Item ID: D350-588-041 Accept ***N900040100*** Setup Start ***NS1***
 Revision ID: Stop ***NS2***
 Item Name: Aft Door Assembly
 Start Date: 1/18/2016 Start Qty: 1.00 ***1*** Cust Item ID:
 Required Date: 1/18/2016 Req'd Qty: 1.00 ***1*** Customer:
 Reference:

DART SERVICE INSTRUCTION

TO AMEND INSTALLATION INSTRUCTIONS D350-588 REV. D AND
INSTRUCTIONS FOR CONTINUED AIRWORTHINESS ICA-D350-588 REV. D
REF TCCA STC SH82-41
FAA STC SH1012NE

A	NEW ISSUE	ML	14.03.24
REV.	DESCRIPTION		BY DATE
DESIGN	ML	DART AEROSPACE LTD HAWKESBURY, ONTARIO, CANADA	
DRAWN	ML		
CHECKED		DRAWING NO.	REV. A
MFG. APPR.	N/A	DSI 9690	SHEET 1 OF 2
APPROVED		TITLE	SCALE
DE APPR.		STRIKER PLATE MOD	NTS
DATE	14.03.24	COPYRIGHT © 2014 BY DART AEROSPACE LTD THIS DOCUMENT IS PRIVATE AND CONFIDENTIAL AND IS SUPPLIED ON THE EXPRESS CONDITION THAT IT IS NOT TO BE USED FOR ANY PURPOSE OR COPIED OR COMMUNICATED TO ANY OTHER PERSON WITHOUT WRITTEN PERMISSION FROM DART AEROSPACE LTD.

Figure 1 Striker Plate

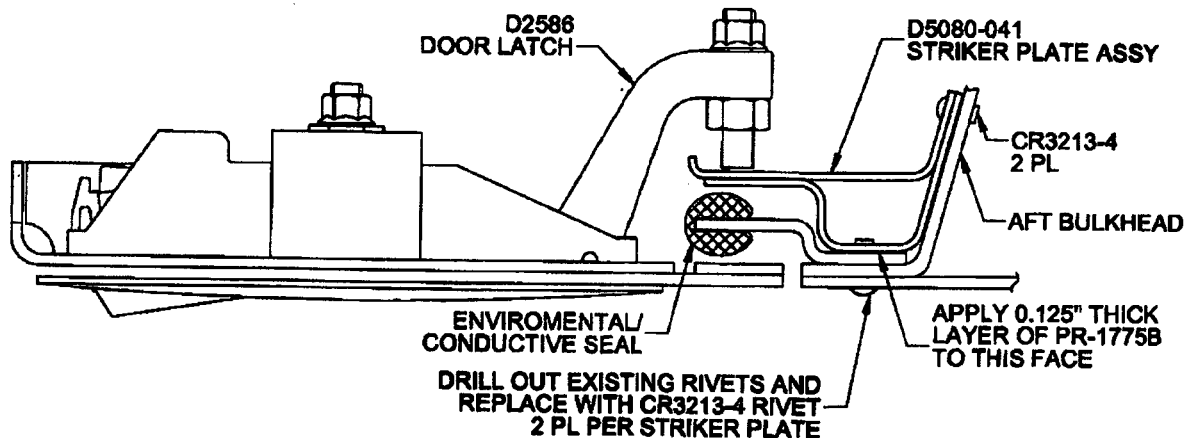
The purpose of this Dart Service Instruction is to provide customers with directions to install a modified striker plate that will provide more clearance around environmental/conductive seals that protrude inboard of the door frame structure on AS355 N/NP models.

- 5) Align D5080-041 striker plate assembly in the previously marked location and transfer drill the $\varnothing 0.1285"$ (#30) holes into the aft bulkhead.

- 8) Deburr holes and remove all sharp edges.
- 9) Touch up all holes in aluminum with chemical conversion coating in accordance with MIL-DTL-5541.
- 10) Apply 0.125" thick layer of PR-1775B ProSeal to the face of D5080-041 per Figure 1.

- 11) Install D5080-041 striker plate assemblies to the aft bulkhead using CR3213-4 rivets of a suitable length, and to the skin of the aircraft using PR-1775B coated CR3213-4 rivets of a suitable length.

588 -041	588 -011	PART NUMBER	DESCRIPTION
X		D350-588-041	AFT DOOR ASSEMBLY
	X	D350-588-011	AFT DOOR FWD HINGE MOD
2	2	D5080-041	STRIKER PLATE ASSY (AS355 N/NP MODELS ONLY)
2	2	D2237	STRIKER PLATE
